Docket Number: 58-0102-1701

**Department of Environmental Quality
Water Quality Standards, IDAPA 58.01.02
Docket No. 58-0102-1701**

DEQ's Response to Comments/Negotiated Rulemaking Summary
Docket No. 58-0102-1701

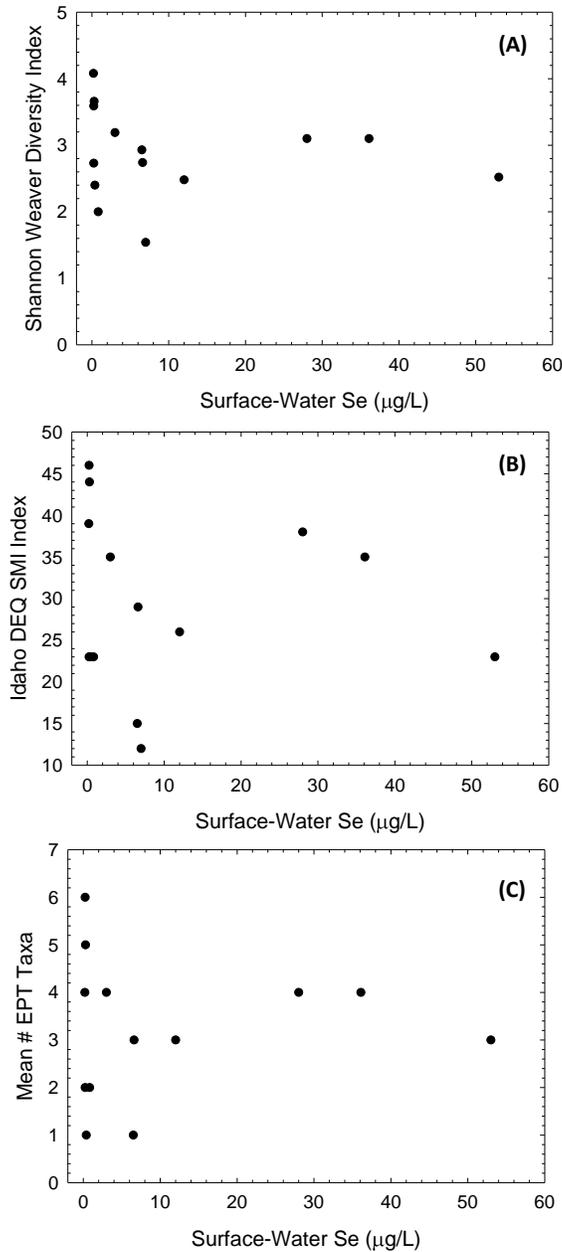
C o m m e n t #	Rule Section/ Subject Matter	C o m m e n t e r	Comment	Response
			<p>development in a fishless water, but rather whether the criterion set upstream in the fishless water is going to be protective of the fish communities downstream. In addition, the selenium criterion is an aquatic life criterion that is intended to protect the entire aquatic community, not just fish within the aquatic community. The method that was utilized to derive the water column criterion element for No Name Creek may result in a value that is not appropriate for that water body and is not protective of the entire aquatic community within that fishless water body. EPA requests that Nu-West provide additional information that demonstrates that the proposed water column criterion elements for No Name Creek are protective of the entire aquatic community of this creek.</p>	<p>presented for No Name Creek was developed specifically to incorporate a fish threshold, because fish are the most sensitive taxa group (USEPA 2016). Fish tissue immediately downstream of the fishless No Name Creek could be evaluated to more directly evaluate the protectiveness of the proposed element to downstream fish. However, based on stakeholder feedback during Idaho's negotiated rulemaking session, Nu-West understood that stakeholders might prefer a numeric water column element for No Name Creek and therefore proposed water column values considering the available information of Se toxicity to aquatic life.</p> <p>Nu-West also understand EPA's request to provide additional information to demonstrate the proposed water column element for No Name Creek is protective of the limited aquatic community resident to No Name Creek. This is addressed as follows.</p> <p>Biological monitoring of No Name Creek was performed by Nu-West between 2013-2016. A detailed description of sampling methods and results is provided in annual Data Summary Reports (GEI 2016a, GEI 2016b, GEI 2016c, Arcadis 2017). The benthic macroinvertebrate [BMI] community was quantitatively sampled each year according to methods outlined in IDEQ (2013) and agency-approved Work Plans / Quality Assurance Project Plans. In brief, at each No Name Creek reach with water present, three replicate samples of BMIs were collected from riffle habitat using a Hess sampler (to capture small-scale variability of BMI populations and provide additional statistical power in interpreting community results); a sweep sample was also collected from non-riffle habitats to provide additional information on the BMI community. BMI samples were preserved in the field and transported to the laboratory, where invertebrates were sorted from debris, counted, and identified to the lowest practical taxonomic level (most often to the species level).</p> <p>Nu-West analyzed BMI parameters relative to ambient surface water Se</p>

Nu-West analyzed BMI parameters relative to ambient surface water Se concentrations to demonstrate the water column element proposed for No Name Creek is also protective of the BMI community resident to No Name Creek. Figure 1 presents this evaluation.

As would be expected for this type of habitat, the BMI data from No Name Creek are somewhat variable. However, there is no indication of Se-related impacts to the site-specific BMI community despite Se

Figure 2. Comparison of whole-body (WB) Se concentrations measured in co-located sculpin and cutthroat trout from Angus Creek and Sheep Creek.

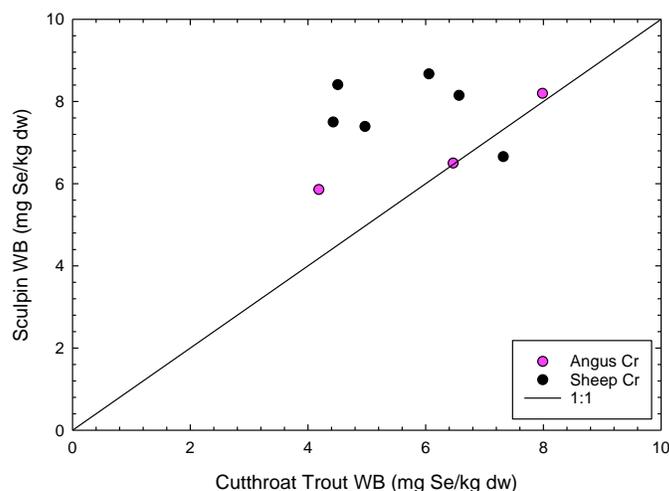
C o m m e n t #	Rule Section/ Subject Matter	C o m m e n t e r	Comment	Response
32	287.01 287.02	1	<p>Table 12 and 13.</p> <p>In order to calculate the water column criterion elements for Angus Creek and No Name Creek, Nu-West has combined fish tissue data from two species, cutthroat trout and sculpin. EPA does not recommend combining data from the two species in order to calculate the water column criterion element. Rather, EPA recommends deriving a water column criterion element for each species and then selecting the more conservative value, so that protection of the more sensitive species is assured. EPA recognizes that for Angus Creek limited data were available, but that likely indicates that more data are necessary for deriving this criterion element rather than combining species data.</p>	<p>DEQ supports Nu-West's Response below.</p> <p>Nu-West Response: "Nu-West understands EPA's recommendation against combining data from two species when calculating a water column element. However, Nu-West believes the approach is reasonable for Angus Creek for several reasons. First, as discussed in the proposal, juvenile salmonids are targeted for fish-tissue collection in accordance with the Interagency Fish Tissue Collection Protocol developed for Southeastern Idaho streams (IDEQ 2016). Similar to sculpin species, juvenile trout feed primarily on invertebrates. Consequently, both species represent trophic level 3 consumers with similar feeding ecologies.</p> <p>For Angus Creek, Nu-West carefully evaluated sculpin and YCT tissue data that were temporally and spatially co-located (i.e., collected from the same location and date in Angus Creek; see Tables 12) and determined that whole-body Se concentrations were not statistically different ($p > 0.05$) between the species. As a result, BAFs are not statistically different between these species in Angus Creek. In addition, Nu-West evaluated the relationship between co-located sculpin and YCT tissue data collected in Sheep Creek (Table 11). The purpose of this analysis was to further understand potential species-specific differences between trout and sculpin using a broader dataset of co-located tissue samples in the UBR watershed. The following figure shows the relationship between whole-body Se concentrations for co-located samples of sculpin and YCT in Sheep Creek and Angus Creek (the solid 1:1 line represents unity).</p> <p>Points to the left of the solid 1:1 line represent sculpin WB Se concentrations that are greater than co-located trout concentrations. These data suggest that sculpin represent a conservative surrogate for trout species when deriving a site-specific water column element for Angus Creek. In contrast, sculpin data were not included in the calculation of the site-specific water column value for</p>

For Angus Creek, Nu-West carefully evaluated sculpin and YCT tissue data that were temporally and spatially co-located (i.e., collected from the same location and date in Angus Creek; see Tables 12) and determined that whole-body Se concentrations were not statistically different ($p > 0.05$) between the species. As a result, BAFs are not statistically different between these species in Angus Creek. In addition, Nu-West evaluated the relationship between co-located sculpin and YCT tissue data collected in Sheep Creek (Table 11). The purpose of this analysis was to further understand potential species-specific differences between trout and sculpin using a broader dataset of co-located tissue samples in the UBR watershed. The following figure shows the relationship between whole-body Se concentrations for co-located samples of sculpin and YCT in Sheep Creek and Angus Creek (the solid 1:1 line represents unity).

Points to the left of the solid 1:1 line represent sculpin WB Se concentrations that are greater than co-located trout concentrations. These data suggest that sculpin represent a conservative surrogate for trout species when deriving a site-specific water column element for Angus Creek. In contrast, sculpin data were not included in the calculation of the site-specific water column value for Sheep Creek since trout were collected at each sampling location and each year in this stream.

Figure 1
Brown Trout BAFs Derived for Background and Reference Sites

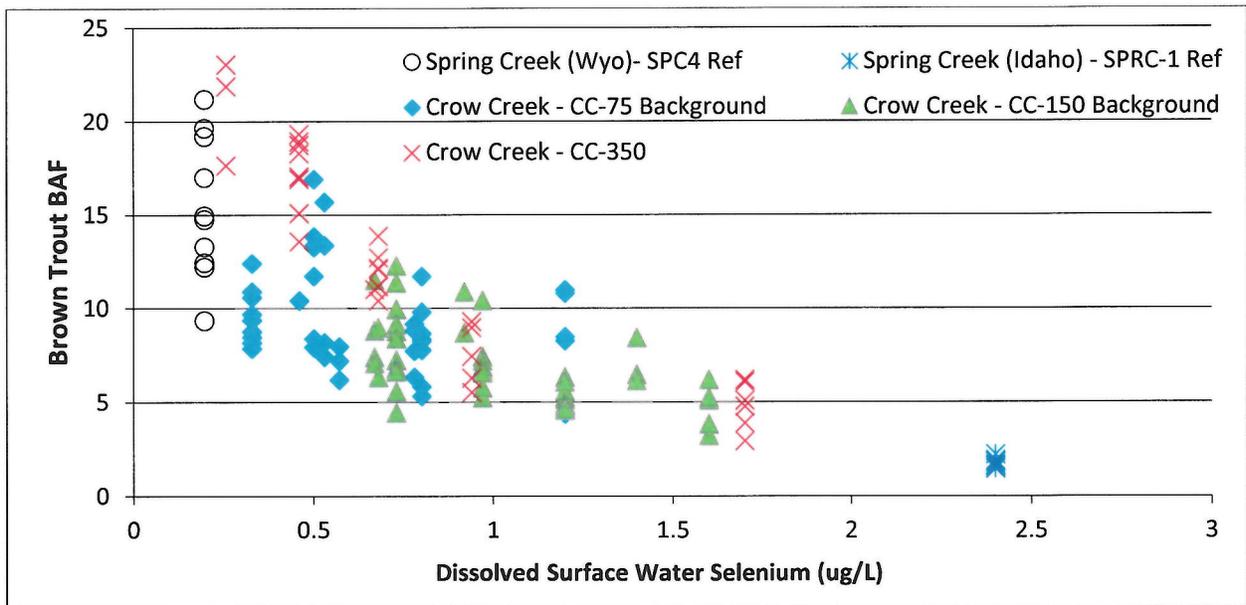
48	287.03 287.04	6	<p>WDEQ/WQD still has concerns regarding the substantial increase in selenium concentrations that occurred during Simplot's study and how the water quality data collected during this time affect the calculation of whole-body and water column elements of the SSSC. These concerns were not addressed in the revised proposal or the Negotiated Rulemaking Summary and are therefore reiterated below.</p> <p>....</p> <p>Water column element As described in the text of the proposal and in Appendix D, the data used for deriving bioaccumulation factors (BAF) and ultimately the</p>	<p>The water column criterion element is calculated using the BAF approach by dividing the fish tissue criterion element by the BAF. For the numerator of this equation, DEQ agrees with Simplot in deriving fish tissue criterion elements from data collected when selenium concentrations in water appeared stable (fall 2007). This ensures that the numerator of the water column element equation is derived from steady-state data. DEQ also agrees that it is valid for Simplot to use median BAF values from data collected 2006-2011 as the denominator of the equation to derive the water column element. The rationale is provided below.</p> <p>Even though selenium concentrations in water began to increase after 2008, whole-body fish tissue concentrations collected in Crow Creek were not</p>

BAFs, if calculated based on individual fish, will always show variability since multiple whole body concentrations can be measured relative to a single surface water concentration. Selenium concentration among individual fish can vary even if the fish are collected from a similar range of selenium water concentrations. This variability, which is greater for lower concentrations, is illustrated in Figure 1.
